UNITED STATES PATENT AND TRADEMARK OFFICE

APPLICATION NO.	FILING DATE	FIRST NAMED INVENTOR	ATTORNEY DOCKET NO.	CONFIRMATION NO.
09/841,570	04/24/2001	Gary Boccadutre	1647001	5425

Office Action Summary	Application No.	Applicant(s)	
	09/841,570	BOCCADUTRE ET AL.	
	Examiner	Art Unit	
	Hadi Shakeri	3723

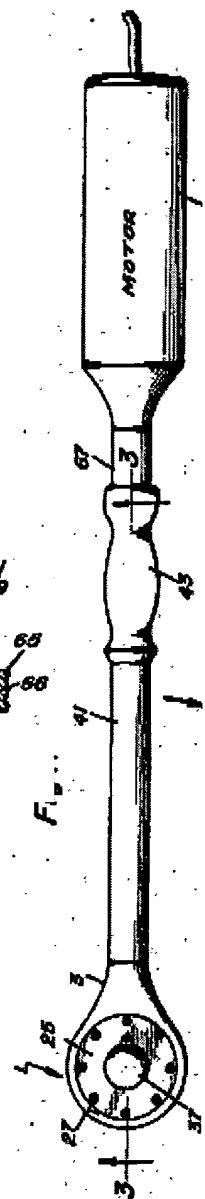
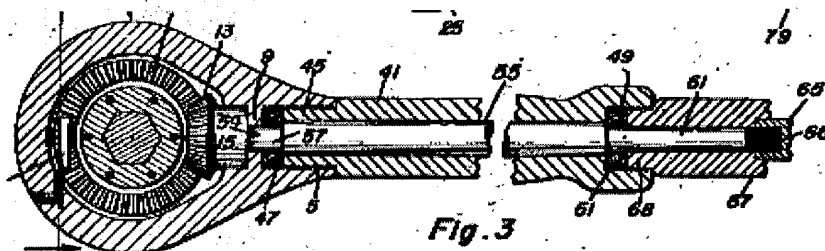
3. Claims 1, 3, 7, 9 and 11 are rejected under 35 U.S.C. 102(b) as being anticipated by Lampke, US Patent No. 2,808,749.

Lampke discloses all the limitations of claims 1, 3, 7, 9 and 11, i.e., power wrench comprising a handle containing a motor; a ratchet extension (41); a ratchet extension shaft 955); and a ratchet head (1).

Regarding claim 3,
wherein the extension
and shaft are removable.

Regarding claims
7 and 9, wherein the heads and the handle are removable, and the extension and the shaft are "fixedly" attached to the handle and the head respectively (fixedly is considered as a fixed attachment and not "unitary").

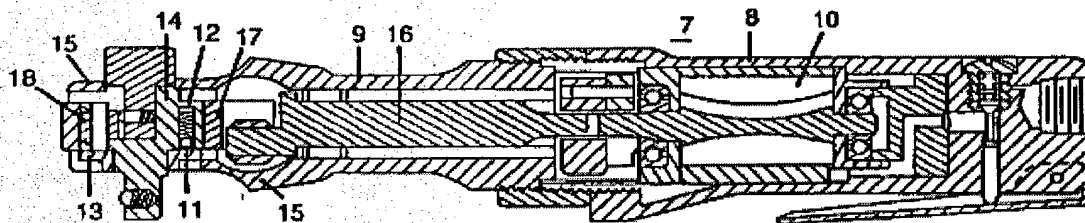
4. Claims 1, 3, 5, 7, 9 and 11 (as best understood) are rejected under 35 U.S.C. 102(b) as being anticipated by Applicant's Admitted Prior Art (AAPA).

As admitted by the Applicant, lines 135 and 236, power ratchet wrench extensions as shown in Fig. 3 are old, thus meeting the claims limitations as explained above.

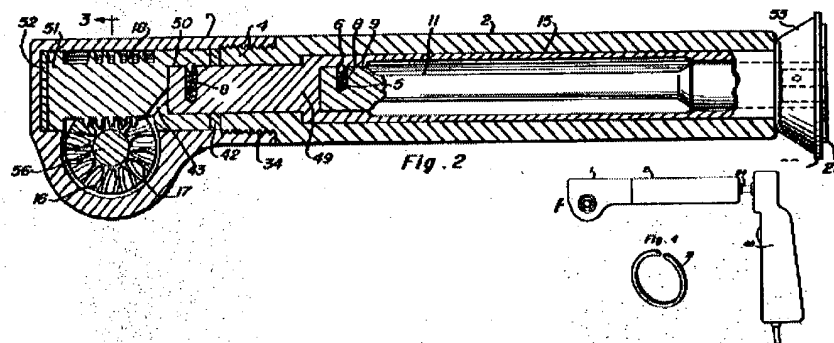
5. Claims 1 and 11 are rejected under 35 U.S.C. 102(b) as being clearly anticipated by D' Haem et al., US Patent No. 4,791,836.

D' Haem et al. clearly anticipates the above claims, e.g., Fig. 2.

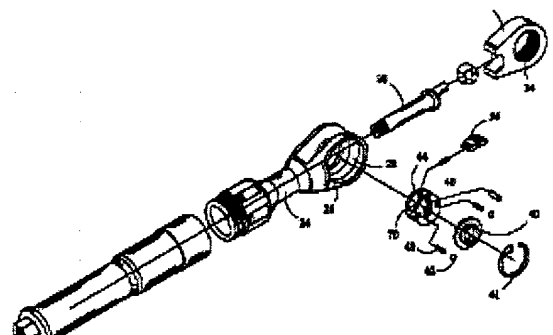
6. Claims 1, 3, 7, 9 and 11 are rejected under 35 U.S.C. 102(b) as being clearly anticipated by Hendrickson, US Patent No. 3,430,510.

Hendrickson clearly anticipates the above claims, e.g., Figs. 2 and 5.
